Office Action Summary

10/624,338

GRONDAHL, CLAYTON M.

With respect to claims 1, 9, 19, and 24, Gail discloses of a seal assembly (see figure below) comprising:

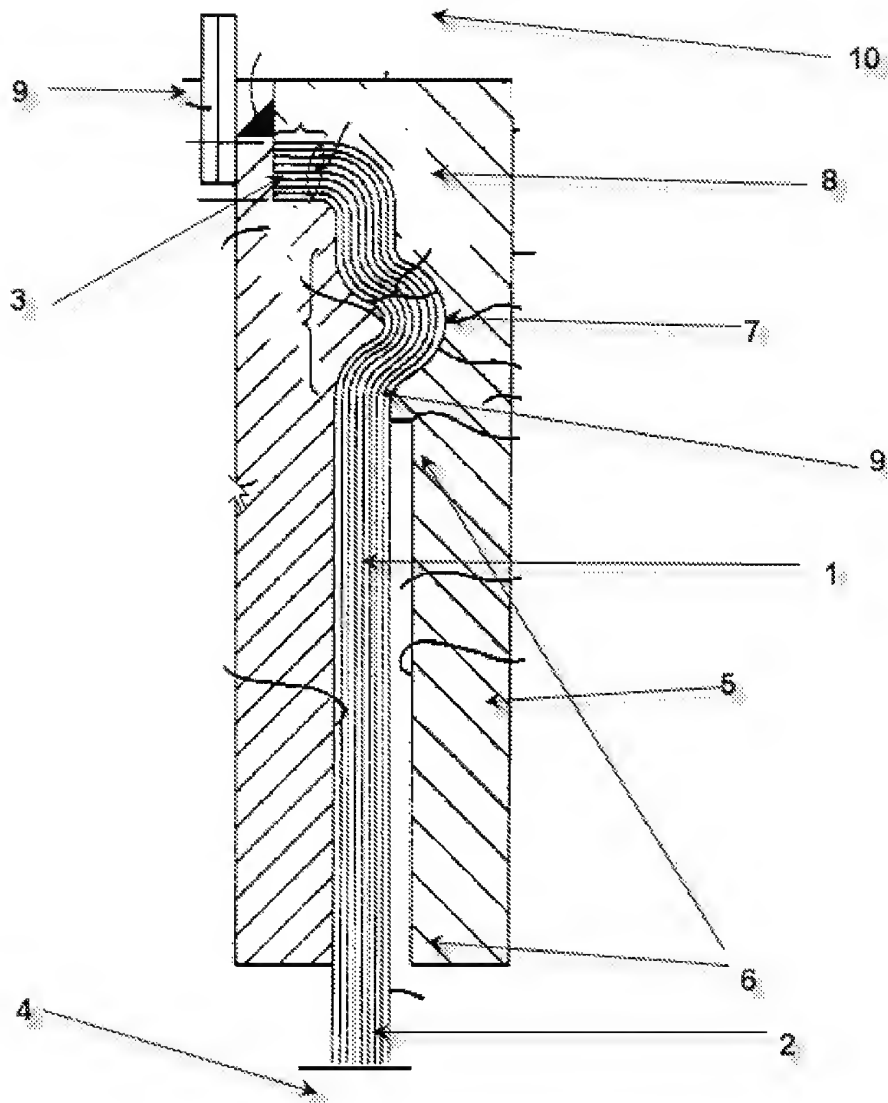
- a non-rotating member (10, or 2 from fig. 1);

- a brush seal (1) adjacent the non-rotating member (10), the brush seal including a plurality of staggered seal members, each brush seal member including:

- a free portion (2) [*adapted to be* angled relative to both a radial axis of the non-rotating member and an axis perpendicular to a radial axis of the non-rotating member (10)]*; and

- a fixed portion (3) that is angled relative to free portion (2) and adapted to be one of substantially parallel (at 3) to and substantially perpendicular to the radial axis of the non-rotating member; and

- a support (5) coupled to a low pressure side of the seal for supporting the free portion (2), the support (5) having a support portion facing a high pressure side of the seal,

- wherein the free portion (2) contacts a distal end (6) in an pressurized operative state (*) and is out of contact with the distal end (6) in an unpressurized inoperative state, the fixed portion (3) of the seal is angled relative to the free portion (2) in both the operative and inoperative states, and the free portion (2) [*is adapted to be* further angled relative to the fixed portion during the pressurized operative state than in the unpressurized inoperative state]*.

Re: Claim 3, wherein the support portion (5) includes a curved surface (7) extending from a proximate end (8) of the support portion (5) to the distal end (6), and the free portion (2) extends tangentially (9) from the curved surface in the operative state.

Re: Claim 4, wherein the proximate end (8) is coupled to a mount portion (9) of the support that mounts the support (5) to a stationary component.

Re: Claim 8, wherein the fixed portion (3) is positioned substantially parallel to the radial axis of the non-rotating member (10), and the free portion (2) is angled out-of-plane relative to the fixed portion (3).

Re: Claim 11, wherein the distal end (6) of the support (5) portion is thinner than a proximate end (8) of the support portion, and the proximate end (8) is in contact with the free portion in the unpressurized state (at 9).

Re: Claim 12, wherein the support portion (5) includes a curved surface (7) extending from a proximate end (8) to the distal end (6).

Re: Claim 13, wherein the proximate end (8) is coupled to a mount portion (9) of the support that mounts the support (5) to a stationary component.

Re: Claim 15, further comprising a holder for mounting the seal assembly to a stationary component, wherein the holder includes a projection for protecting the free portion (see area below and around 8 in the figure above).

Re: Claim 21, wherein the support portion (5) includes a curved surface (7) extending from a proximate end (8) to the distal end (6).

Re: Claim 23, wherein the fixed portion (3) is positioned substantially perpendicular to a longitudinal axis of a component (4) to be sealed, and the free portion (2) is angled out-of-plane relative to the fixed portion (3).
